Access Compliance Report

Public Rights-of-Way

(Curb Ramps)

Intersection ID: 44906	Main Street: OAK_DR	Cross Street: HAZELCROFT_LN	Location: SE
ADA ID: C5B5DD3762C2	Ramp Type: PerpDiag	Initial Pass/Fail: Fail	Overall Compliance: No
Severity Score: 31.25			
Codes/Mitigation Info/Possible Solution		Field Measurements/Component Compliance

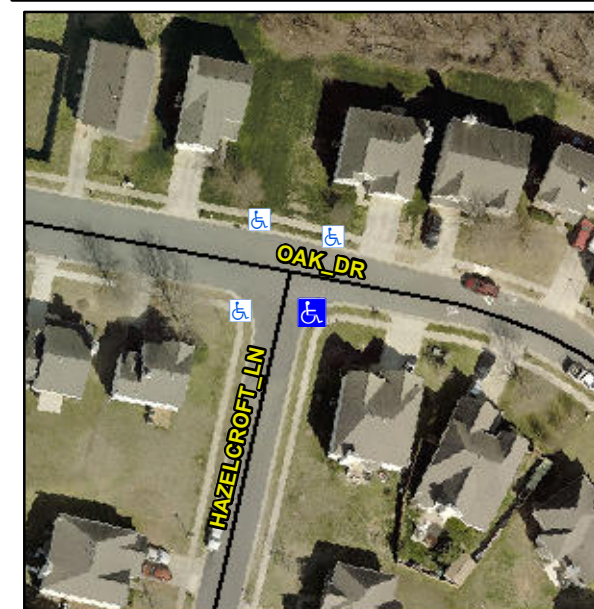
Not Found, R304.5.1, R304.2.2, R304.5.3

Compliance	Description	Data	Compliance	Description	Data
N/A	Ramp Length (in)	48.0	No	Ramp Slope (%)	8.6
No	Ramp Width (in)	34.0	No	Ramp XSlope (%)	3.9
N/A	Flare Type LT	N/A	N/A	Flare Type RT	N/A
N/A	Flare Slope LT (%)	N/A	N/A	Flare Slope RT (%)	N/A
N/A	Flare Traversable LT?	N/A	N/A	Flare Traversable RT?	N/A
N/A	Landing Length (in)	N/A	N/A	DWS Provided?	N/A
N/A	Landing Width (in)	N/A	N/A	DWS Contrast?	N/A
N/A	Landing Slope (%)	N/A	N/A	DWS Length (in)	N/A
N/A	Landing X Slope (%)	N/A	N/A	DWS Full Width?	N/A
N/A	Landing Curb? (Y/N)	N/A	N/A	DWS Offset (in)	N/A
N/A	Shared Landing?	N/A			
N/A	Gutter Ponding?	N/A	N/A	Gutter Slope (%)	N/A
N/A	Gutter Lip Ht (in)	N/A	N/A	Gutter X Slope (%)	N/A
N/A	Painted X Walk1?	No	N/A	Painted X Walk2?	No
	X Walk 1 Direction	To NE		X Walk 2 Direction	To NW
N/A	X Walk 1 Width (in)	N/A	N/A	X Walk 2 Width (in)	N/A
	X Walk 1 Slope (%)	6.0		X Walk 2 Slope (%)	0.0
	X Walk 1 X Slope (%)	1.6		X Walk 2 X Slope (%)	3.2

Remove & Replace Curb Ramp With Two New Directional Ramps or Equivalent.
